AUDIT FINDINGS AND RECOMMENDATIONS

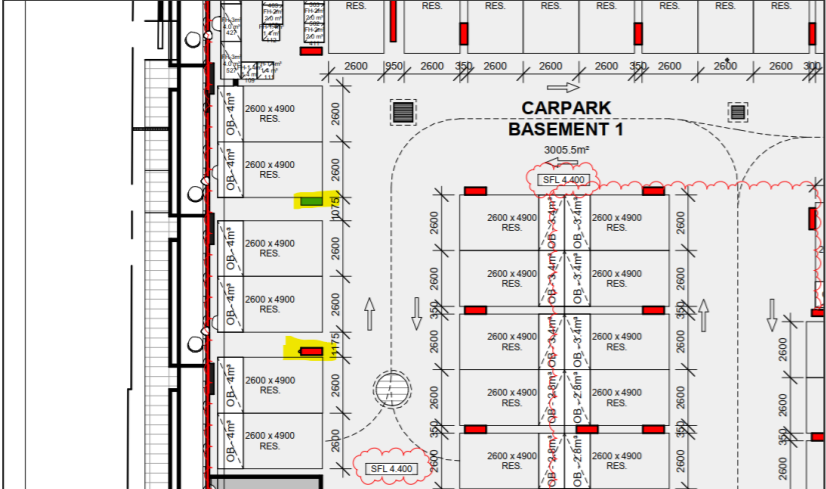
Audit Findings	Recommendations (P) Primary (ST) Step Towards (S) Supporting (N) Non Safe-System	Level of Risk	Safe System Energy	Designer/Project Manager Response
Lower Gound Level, Basement Level 01and Basement Level 02				
<p>1. The location of some columns with respect to car parking spaces (throughout the basement levels) as shown on the architectural plans do not accord with the car parking clearance envelope requirement of AS/NZ 2890.1:2004 or Clause 52.06 of the Planning Scheme. While not a significant safety concern, this could make the spaces more difficult access, and could affect car door opening.</p> <p>Examples of non-conforming column locations are shown below. Please note that this does not show all non-conforming columns.</p> 	<p>Review the design of the car park and column locations, having regard to Figure 5.2 of AS/NZS 2890.1:2004 and/or Diagram 1 of Clause 52.06 as appropriate. (N)</p>	<p>Note</p>	<p>Not Applicable</p>	<p>Accepted. Column locations to be modified where possible, subject to structural constraints.</p>

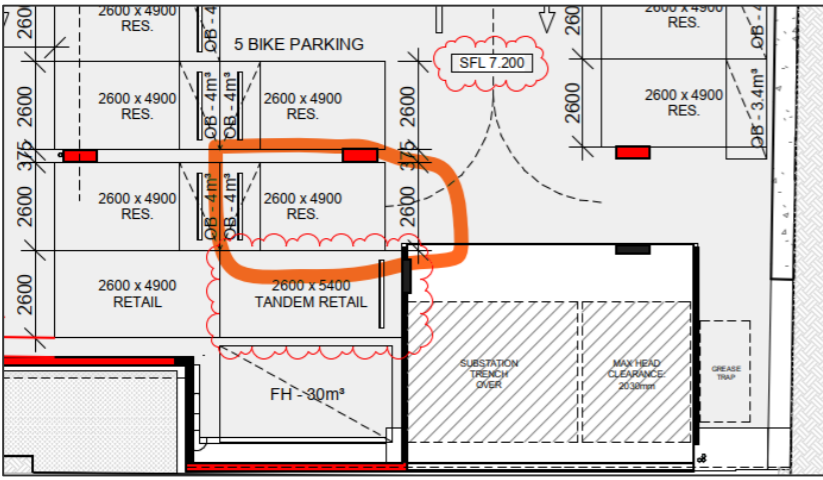
Audit Findings	Recommendations (P) Primary (ST) Step Towards (S) Supporting (N) Non Safe-System	Level of Risk	Safe System Energy	Designer/Project Manager Response
Lower Gound Level				
<p>3. Car parking space located at the south east corner of the lower ground level has a structure impeding into its accessway. This would make the space more difficult to access.</p> <p>Please refer to the PDF extract attached below.</p> 	<p>Review the design of the car park and accessway, having regard to the design requirements of Clause 52.06 of the Planning Scheme. (N)</p>	Note	Not Applicable	<p>Agreed. It has been recommended that the space is converted to a tandem space with the space to the west, or removed.</p>
<p>4. The pedestrian sight triangle on the eastern side of the access driveway does not meet the planning scheme requirement. It is acknowledged that the Planning Scheme requirement is for the prescribed area to be 'at least 50% clear of obstructions.'</p> 	<p>Review options to reduce obstructions within the pedestrian sight triangle on the eastern side of the driveway.</p> <p>Ideally this would involve a more permeable structure which couldn't completely obscure the view to a pedestrian, however it is acknowledged that there are constraints beyond the site boundary that would affect sightlines. (P)</p> <p>Alternative measures such as a convex mirror could be considered to improve sightlines. (S)</p>	Rare Minor Negligible	Within Tolerable	<p>Accepted. Plans updated to include a convex mirror at the access to improve sightlines. Noting that the only obstruction is the existing built form of the adjacent property.</p>

Basement Level 01

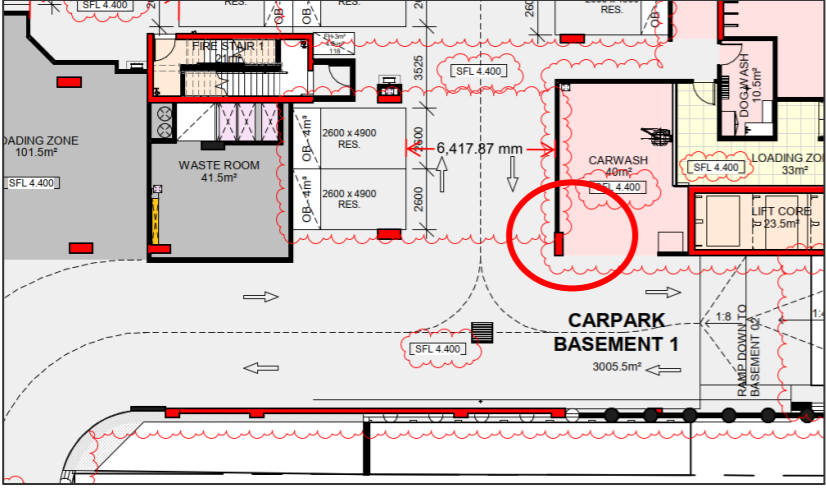
Audit Findings	Recommendations (P) Primary (ST) Step Towards (S) Supporting (N) Non Safe-System	Level of Risk	Safe System Energy	Designer/Project Manager Response
<p>5. Sight lines of the vehicles approaching from the accessway to turn right is obstructed by the walls. This is shown in the extract below.</p> <p>Additionally it is suggested that the intersection of these two aisles could benefit from line marking to define priorities.</p> 	<p>Consider making the wall permeable. This will allow for vehicle turning right from the accessway to get to the exit ramp to have a clear sightlines to the ramp. (P)</p> <p>Alternatively, consider providing wall mounted convex mirror to mitigate the sight line issue. (S)</p> <p>Consider providing line marking to define priorities at this location. (S)</p>	<p>Rare Minor Low</p>	<p>Within Tolerable</p>	<p>Accepted. Plans updated to include a convex mirror to improve sightlines.</p>

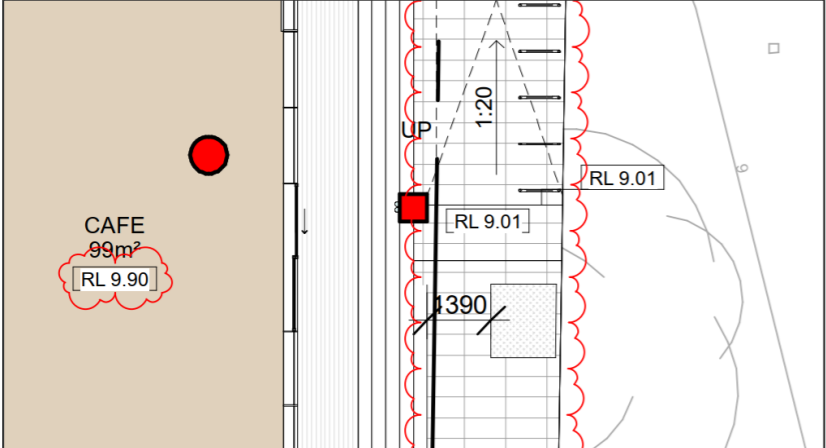
Upper Ground Level				
<p>6. The bicycle parking rails proposed on the Boundary Road footpath are located close to the kerb line, particularly the rails towards the southern end of the site frontage. Bicycle rails typically measure about 1.0 m in length, while the Australian Standard for bicycle parking (AS 2890.3) requires an allowance of 1.8 m for the length of a bike. This means that a bicycle parked on one of these rails will extend beyond the front and back of the rail. With the rail being close to the kerb line, the bike could protrude towards and perhaps into the kerbside parking provision. Similarly the bike could extend back towards the columns that are proposed at the back of the footpath, creating a pinch point which could be difficult to negotiate for users with wheelchairs or prams.</p> 	<p>Review the bicycle parking along the Normanby Road frontage to ensure an appropriate bicycle parking envelope is provided. This should ideally provide a minimum 300 mm clearance between the envelope and the adjacent parking provisions, and a minimum 1.2 m (but preferably 1.5 m) offset from the columns to the west of the spaces. The spaces could be rotated to a 60 degree or 45 degree angle if that helps to achieve appropriate clearances.</p>	<p>Rare Minor Low</p>	<p>Within Tolerable</p>	<p>Accepted. Plans updated to provide bicycle hoops at 45 degree angle, minimising any intrusion into the footpath from parked bicycles.</p>
